ALERT SERVICE BULLETIN

407-24-134

12 February 2024

SUBJECT: Tailboom Attachment Hardware and Fittings, Inspection of

Figure 3 - Gap check at the upper left tailboom attachment interface with tailboom and hardware installed.

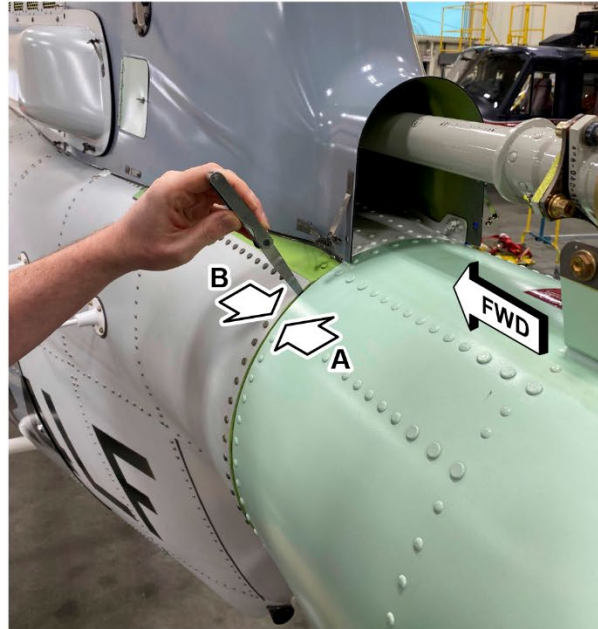
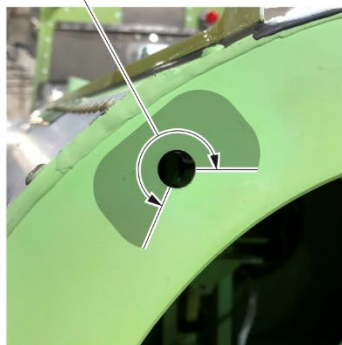
1. From the left side of the fuselage, using a strong light source and a feeler gauge, inspect for a gap at the upper left attachment interface between the aft fuselage and the tailboom. The entire tailboom forward bulkhead machined / hot bonded shim surface must be in contact with the aft fuselage bulkhead. Figure 3 shows the inspection area for possible gap between the machined / hot bonded shim and the

aft fuselage bulkhead. If a 0.003 inch (0.076 mm) feeler gauge or thicker can be inserted in the joint up to the bolt shank, contact Product Support Engineering for further instructions.

Figure 4 Tailboom Attachment Hardware

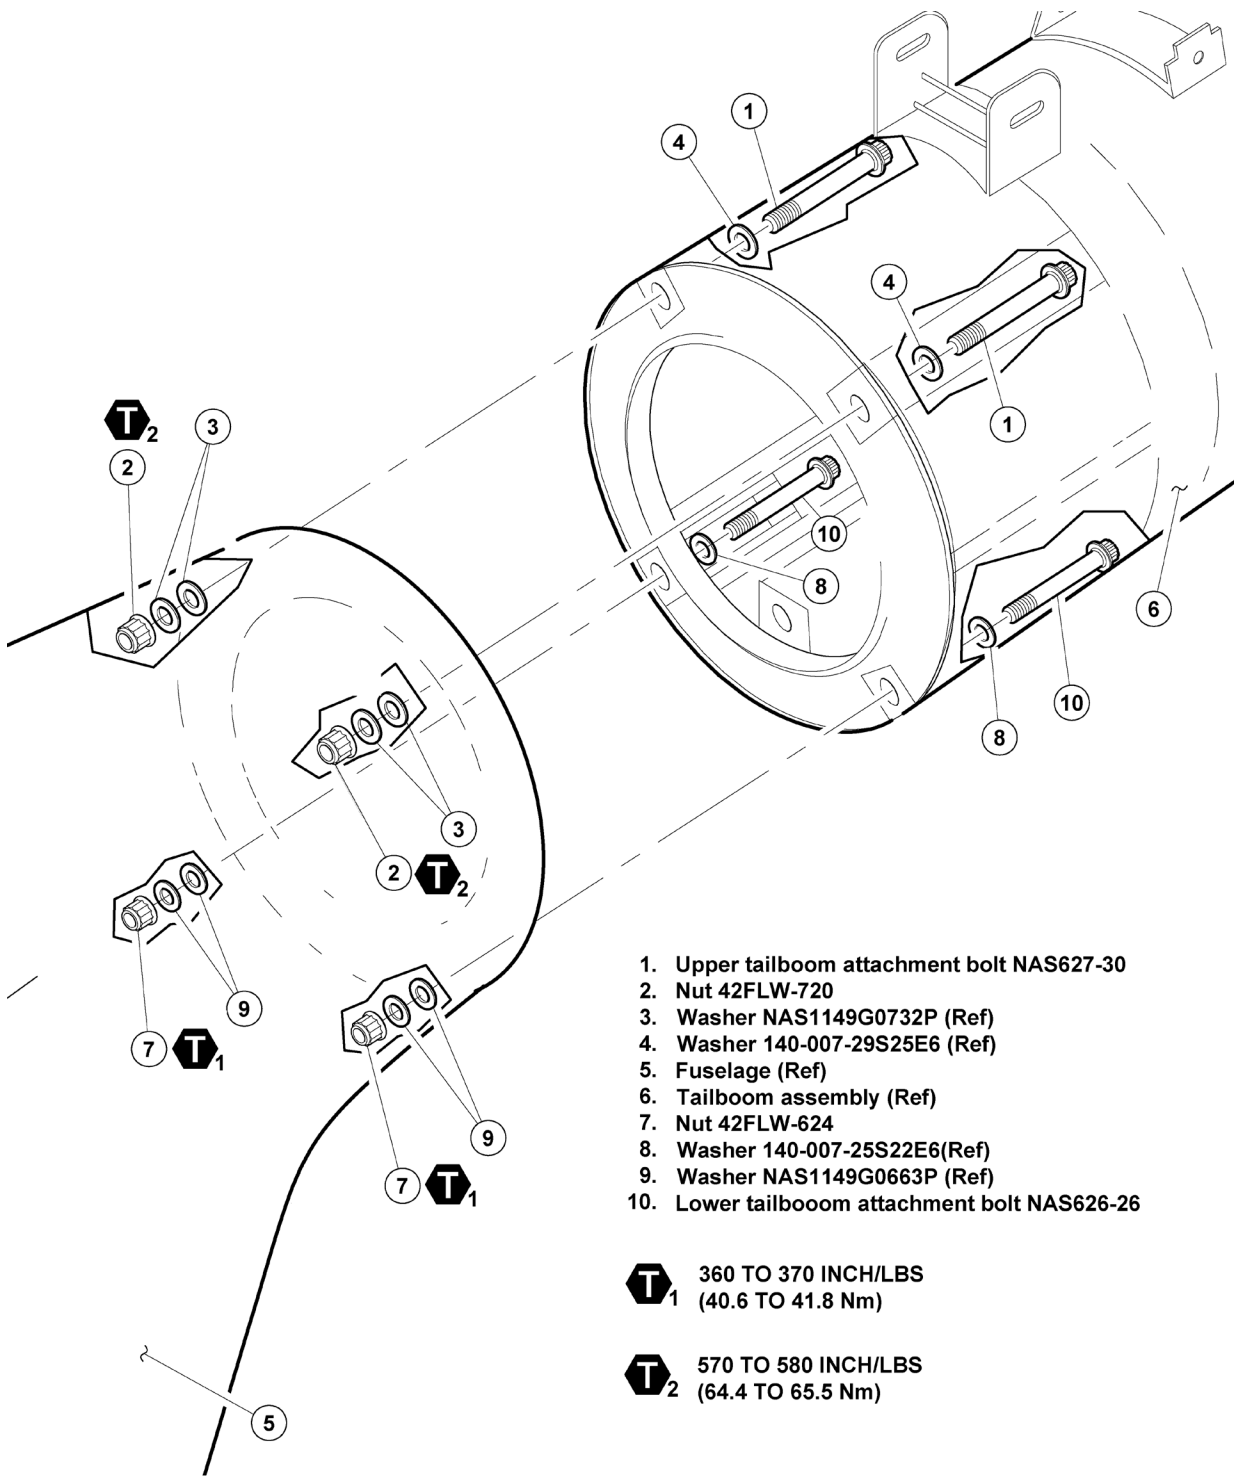
The torque values of the upper and lower nuts (2 and 7, Figure 4) are different. Refer to Figure 4 for the specified torque values.

For torque check purposes, the assembly torque to be applied is the minimum specified torque, plus the minimum acceptable tare torque of 14 inch-pounds (1.58 Nm) for the upper nuts and 9.5 inch-pounds (1.07 Nm) for the lower nuts (BHT-ALL-SPM, Chapter 2, Standard Practices Manual).

- e. Do a torque check of the 3 remaining tailboom to the aft fuselage attachment nuts (2 and 7, Figure 4) ([DMC-407-A-53-01-00-00A-720A-A](#)).
 - (1) If a nut fails the torque check, replace the affected bolt(s) and nut(s) with new bolt(s), nut(s), and washer(s) as applicable. Retain removed hardware for further investigation by Product Support Engineering.
 - (a) Refer to ([DMC-407-A-53-01-00-00A-720A-A](#)) for hardware installation procedures.
- f. After final torque is applied, apply corrosion preventive compound (C-586) to the head of the bolt, washers, nut, and the exposed threads.
- g. After 1 to 5 flight hours, perform the Tailboom Attachment Hardware Torque Check special inspection at every location where new hardware was installed

The torque values of the upper and lower nuts (2 and 7, Figure 4) are different. Refer to Figure 4 for the specified torque values.

For torque check purposes, the assembly torque to be applied is the minimum specified torque, plus the minimum acceptable tare torque of 14 inch-pounds (1.58 Nm) for the upper nuts and 9.5 inch-pounds (1.07 Nm) for the lower nuts (BHT-ALL-SPM, Chapter 2, Standard Practices Manual).

5. Do a torque check of the tailboom to the aft fuselage attachment nuts (2 and 7, Figure 4) ([DMC-407-A-53-01-00-00A-720A-A](#)).
 - a. If a nut fails the torque check, replace the affected bolt(s) and nut(s) with new bolt(s), nut(s), and washer(s) as applicable. Retain removed hardware for further investigation by Product Support Engineering.
